SOLICITATION AMENDMENT MODIFICATION DE L'INVITATION

Title - Sujet CCGC Mechanical and Sprinklers	
Solicitation No. - N° de l'invitation EB144-190543/A	Amendment No. - N° modif. 008
Client Reference No. - N° de référence du client EB144-19-0543	Date 2018-08-14
GETS Reference No. - N° de référence de SEAG PW-\$PWA-121-5750	
File No. - N° de dossier PWA-8-80020 (121)	CCC No./N° CCC - FMS No./N° VME
Solicitation Closes - L'invitation prend fin at - à 02:00 PM on - le 2018-08-21	Time Zone Fuseau horaire Atlantic Daylight Saving Time ADT
F.O.B. - F.A.B. Plant-Usine: <input type="checkbox"/> Destination: <input checked="" type="checkbox"/> Other-Autre: <input type="checkbox"/>	
Address Enquiries to: - Adresser toutes questions à: Russell (PWA), Alex	Buyer Id - Id de l'acheteur pwa121
Telephone No. - N° de téléphone (902) 401-8180 ()	FAX No. - N° de FAX (902) 496-5016
Destination - of Goods, Services, and Construction: Destination - des biens, services et construction:

ADDENDUM NO. 2

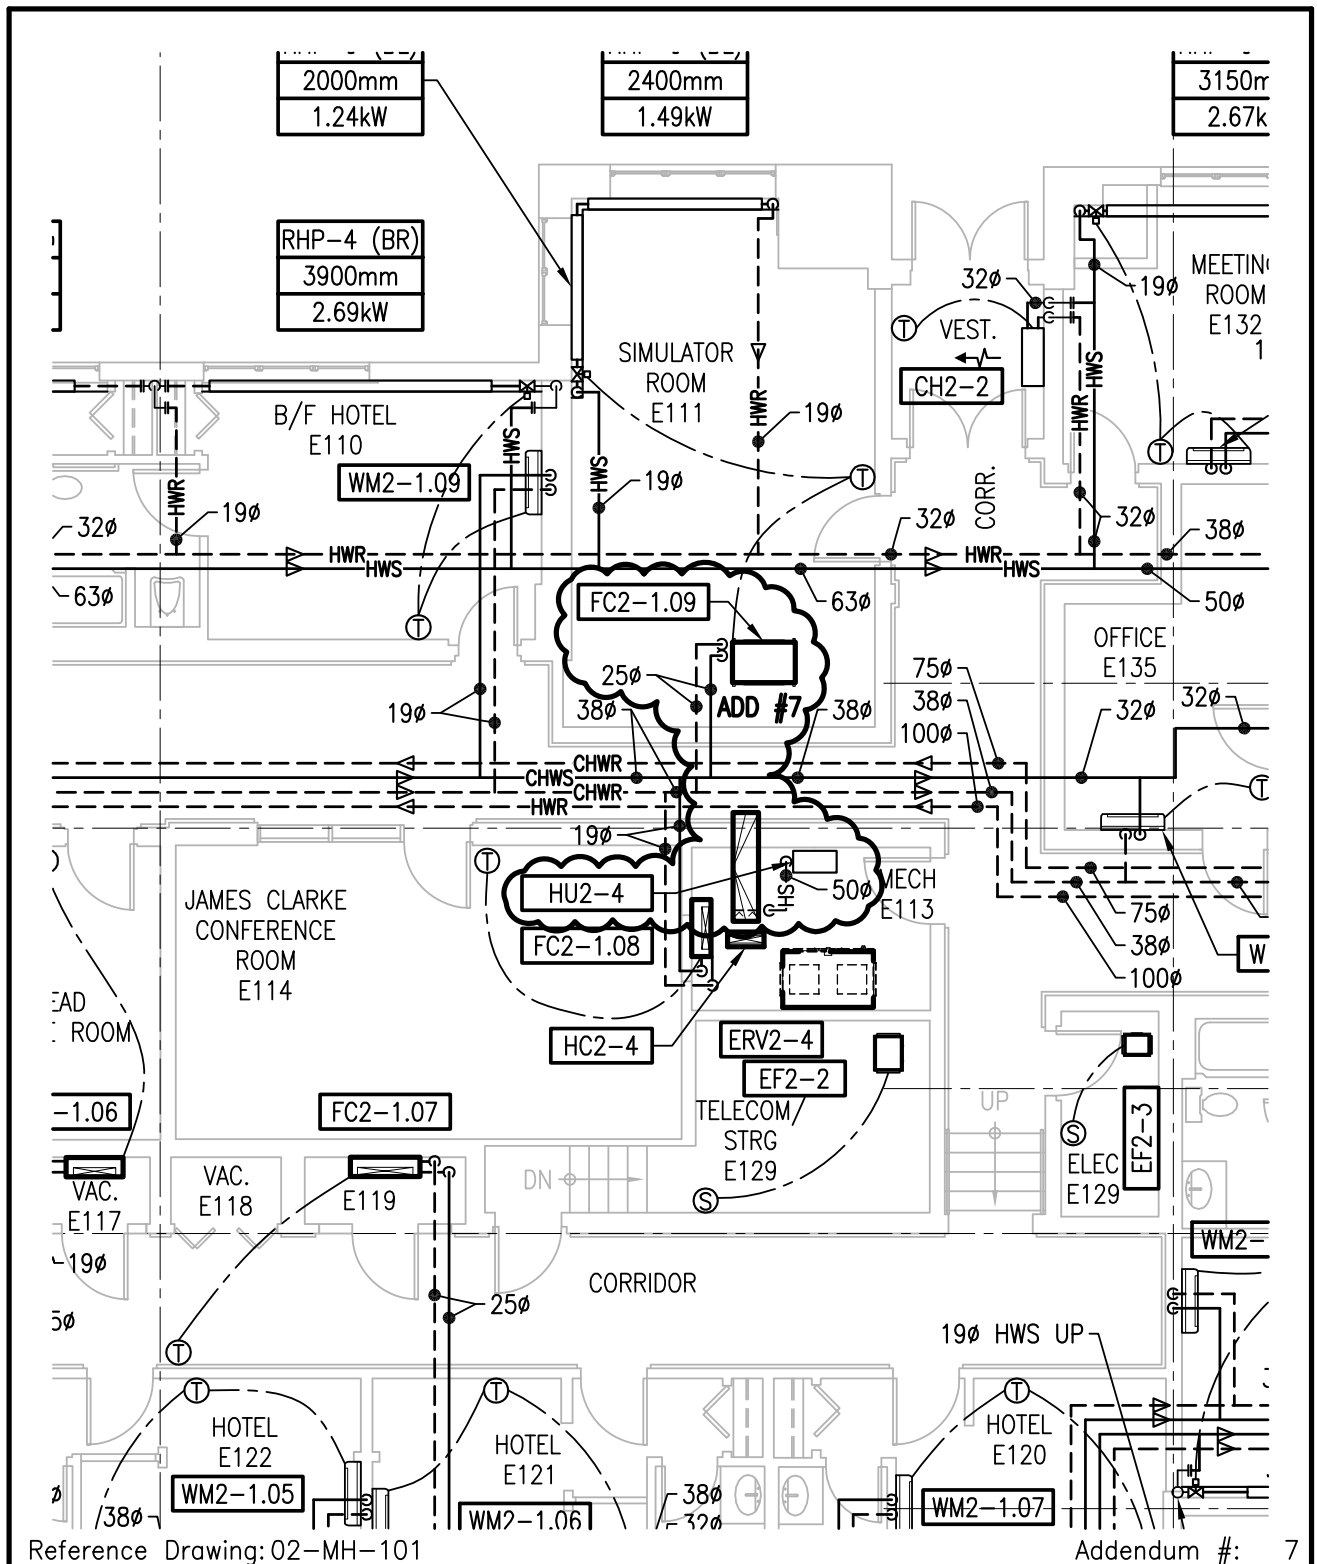
Item 3.24 DRAWING 02-MH-101 HVAC PIPING ARCTIC LEVEL 100 & 200 NEW WORK

- .1 Revise location of CHWS & CHWR piping to relocated fan coil FC2-1.09, and add Humidifier HU2-4 to Mech Room E113 per Sketch 02-MH-SK001 Humidifier HU2-4 Mech Rm E113 dated 2018-08-10 (This Addendum).

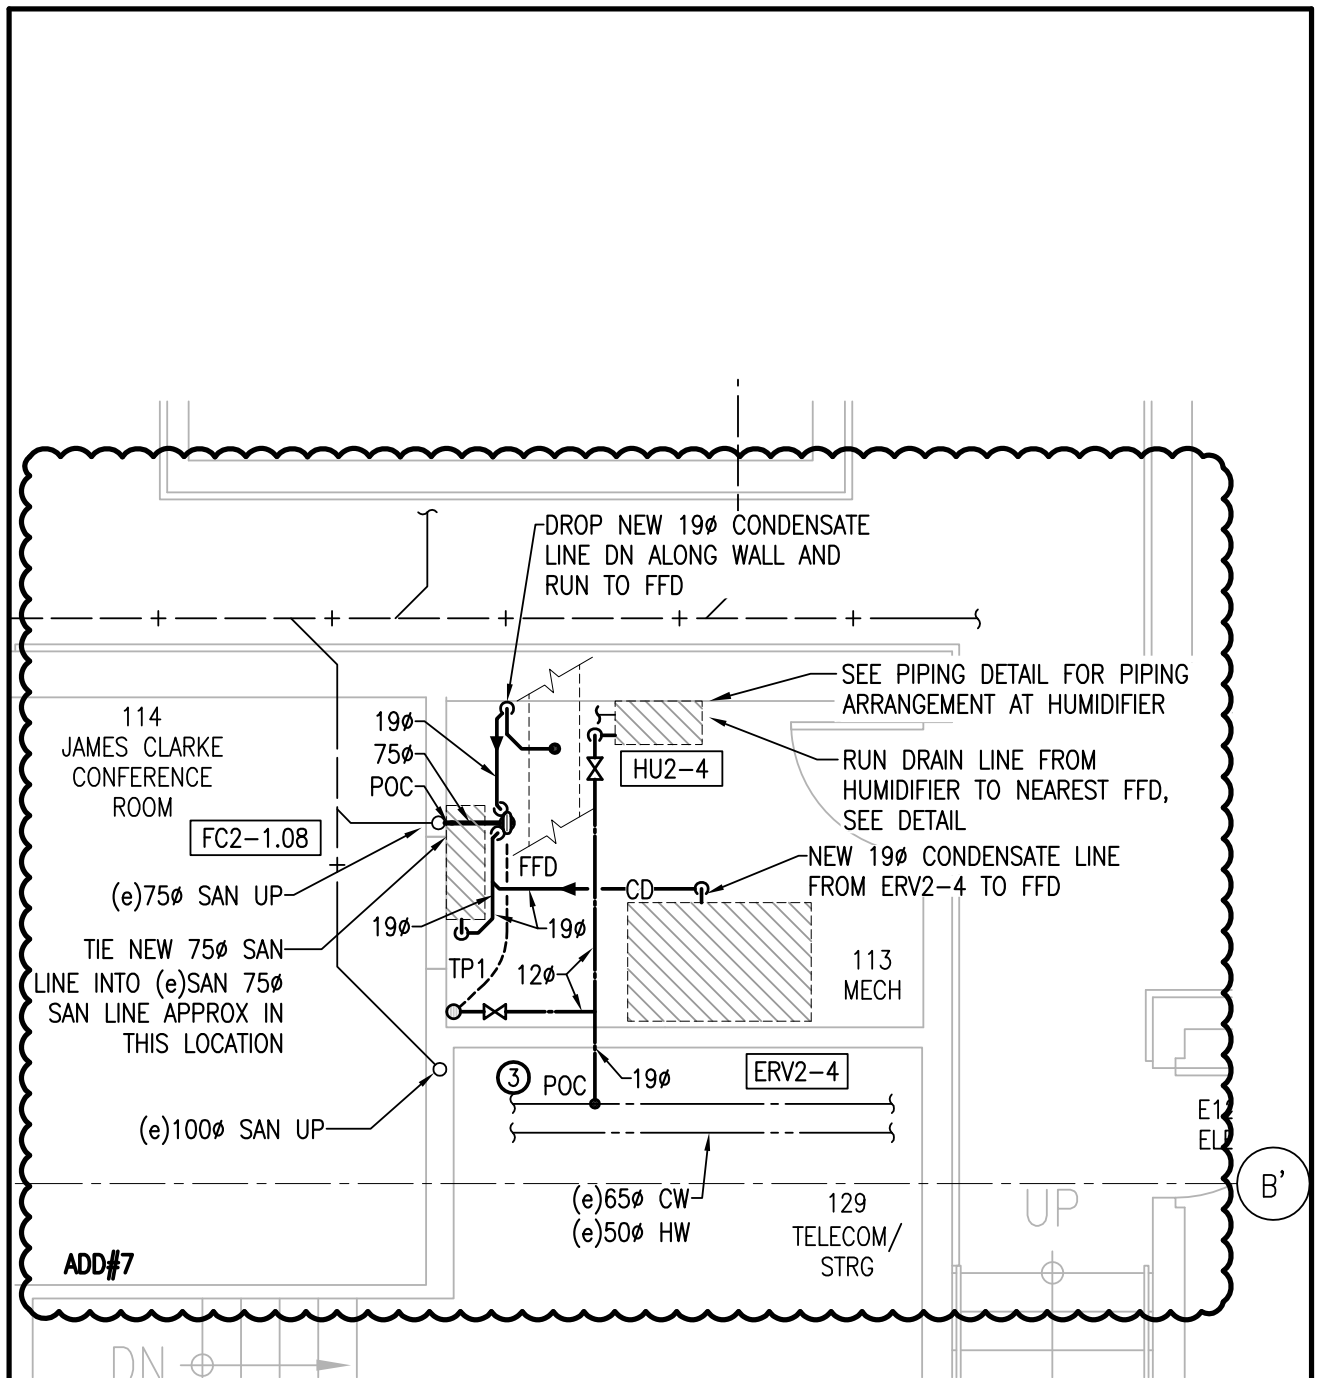
- .1 Add humidifier HU2-4 to Mech Room E113 per Sketch 02-MP-SK001 Addition of Humidifier HU2-4 in Mech Rm 113 dated 2018-08-10 (This Addendum).
- .2 Revise condensate drain piping to relocated fan coil FC2-1.09 per Sketch 02-MP-SK002 Relocated FC2-1.09 Condensate Line Addition dated 2018-08-10 (This Addendum).

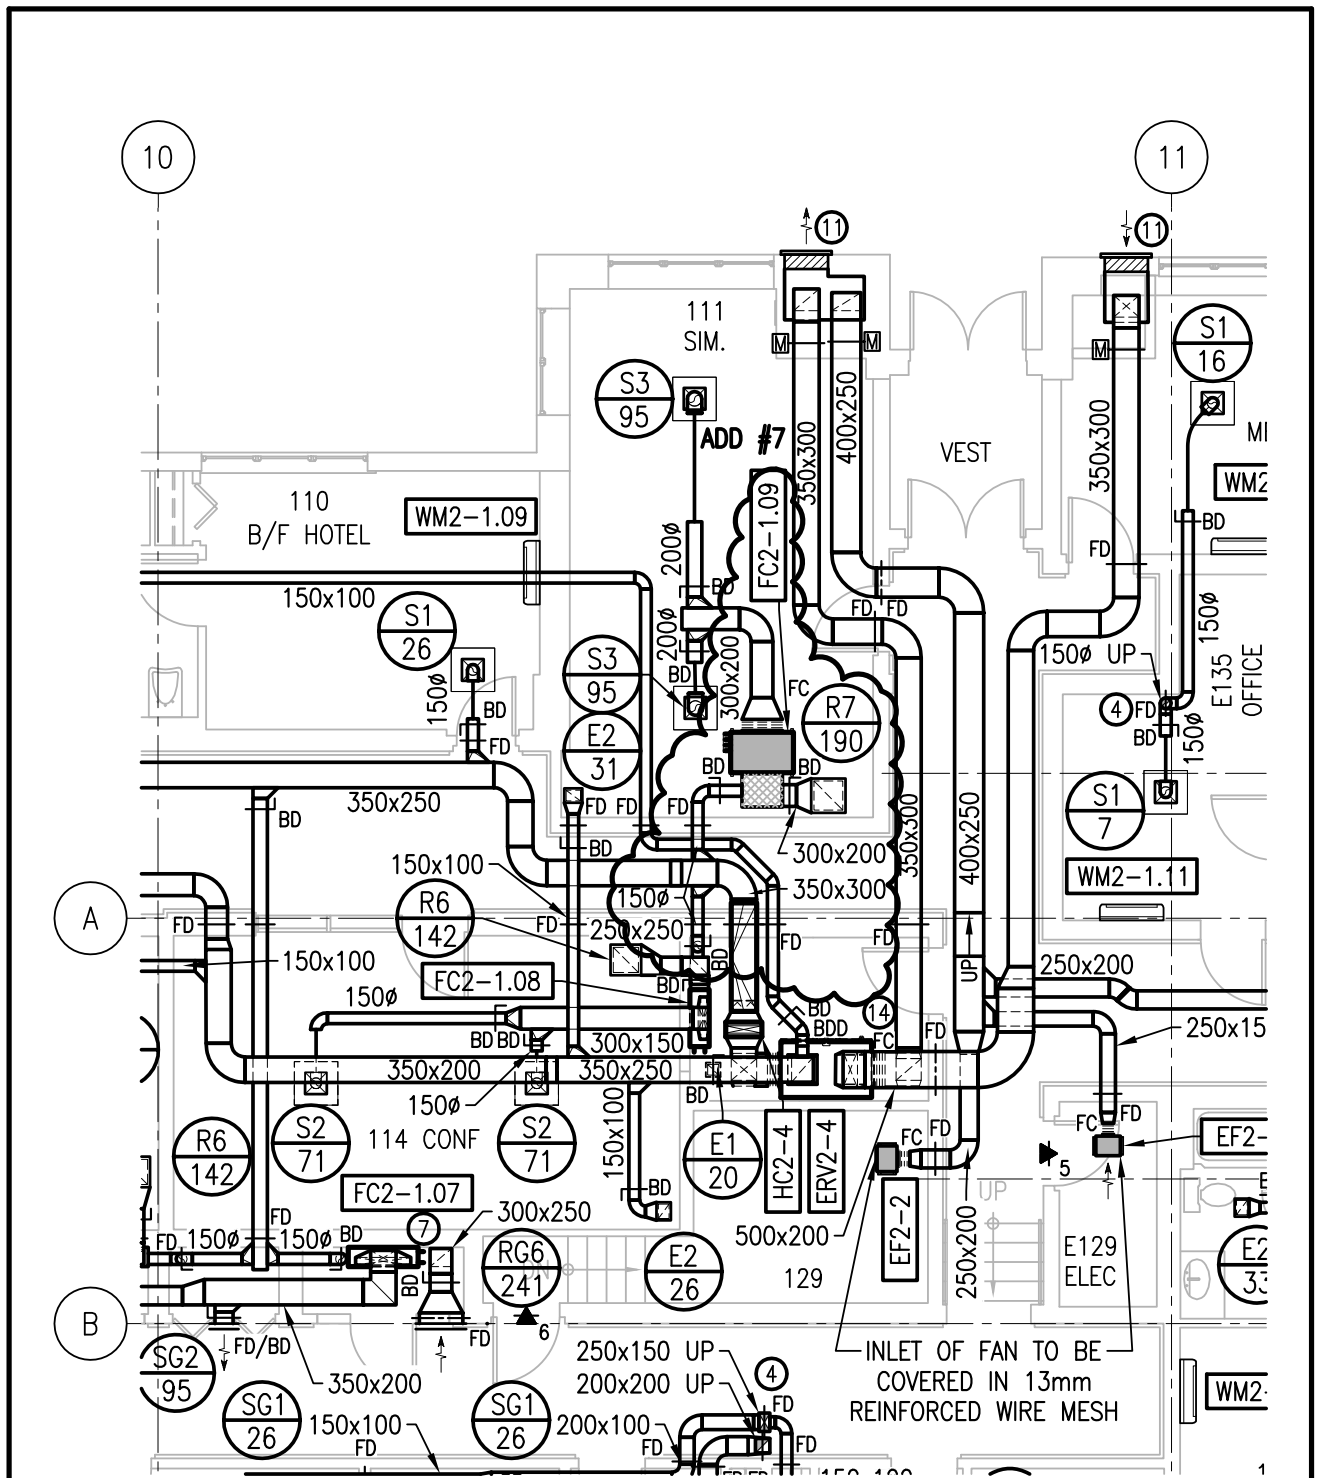
Item 3.27 DRAWING 02-MV-101 VENTILATION ARCTIC LEVEL 100 & 200 NEW WORK

- .1 Revise location of fan coil FC2-1.09 and associated ductwork per Sketch 02-MV-SK001 Fan Coil FC2-1.09 Revisions dated 2018-08-10 (This Addendum).

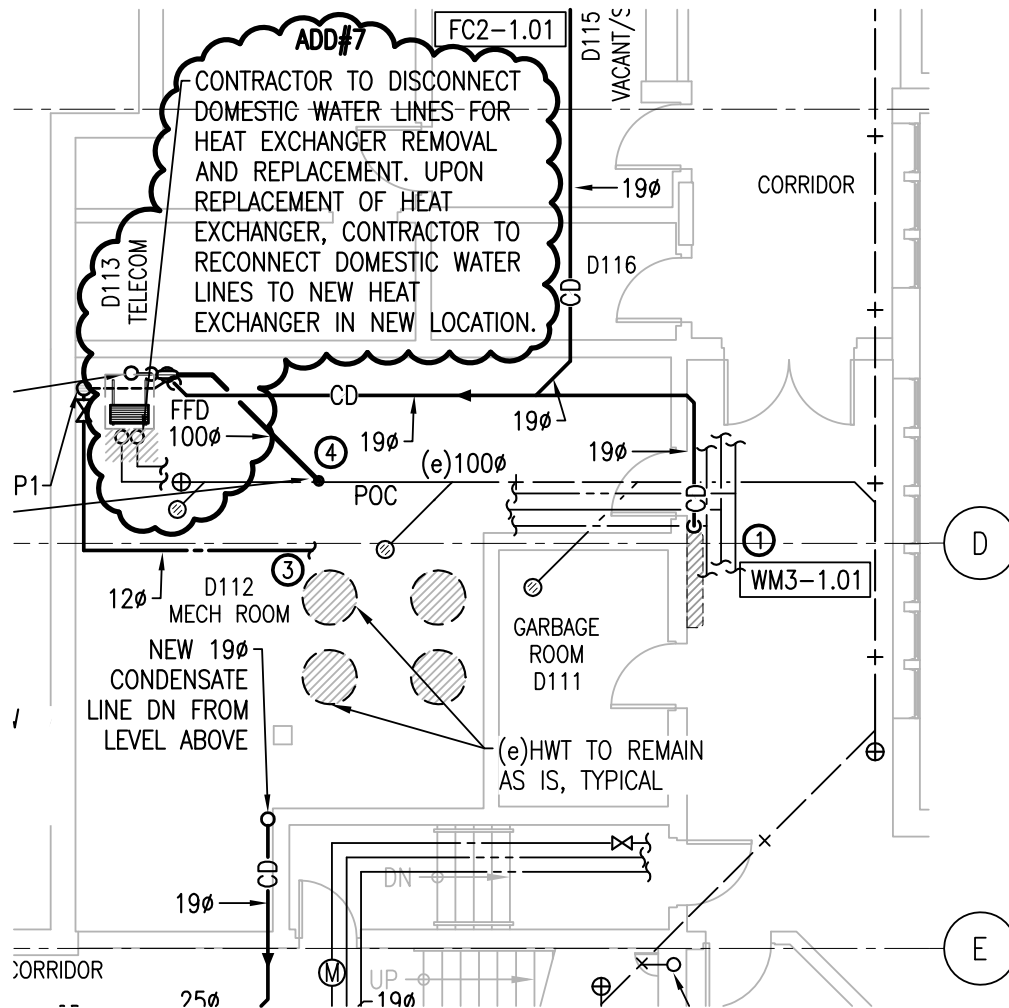
Item 3.30 DRAWING 03-MP-103 PLUMBING GREAT LAKES LEVEL 100 & 200 NEW WORK

- .1 Revise domestic water lines for heat exchanger removal and replacement in Mechanical Room D112 per Sketch 03-MP-SK001 03 – Pacific/Great Lakes Heat Exchanger Revision dated 2018-08-10 (This Addendum).

Reference Drawing: 05-MC-101

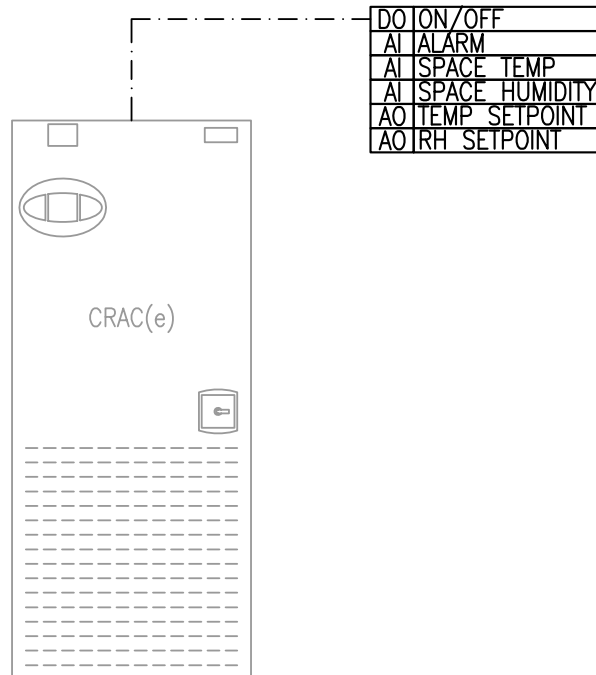
Item 3.42 DRAWING 05-MC-101 CONTROLS – TELC/MCTS/MECKENZIE SCHEMATICS

- .1 Revise the drawing as per the attached Sketch 05-MH-SK001 (This Addendum).

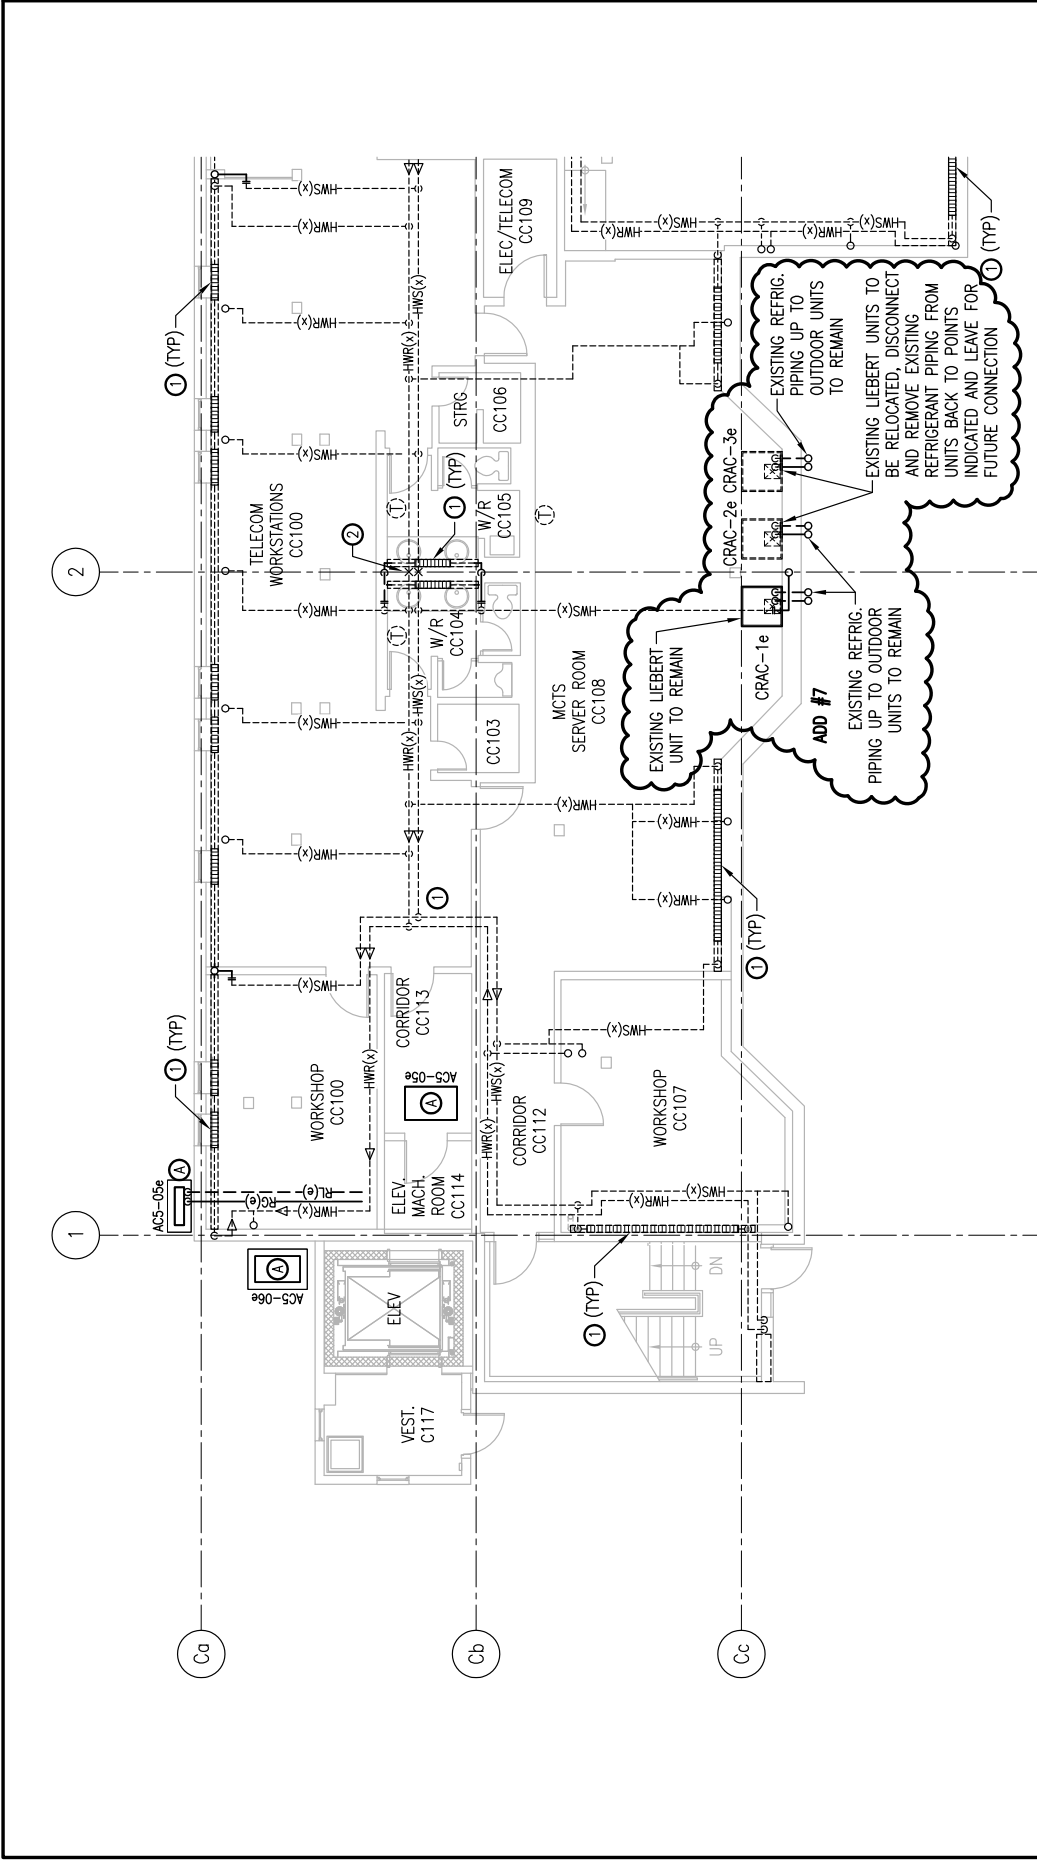
Item 3.43 DRAWING 05-MDH-101 HVAC PIPING - TELC/MCTS – LEVEL 100 – 200 DEMOLITION

- .1 Revise the drawing as per the attached Sketch 05-MDH-SK001 (This Addendum).
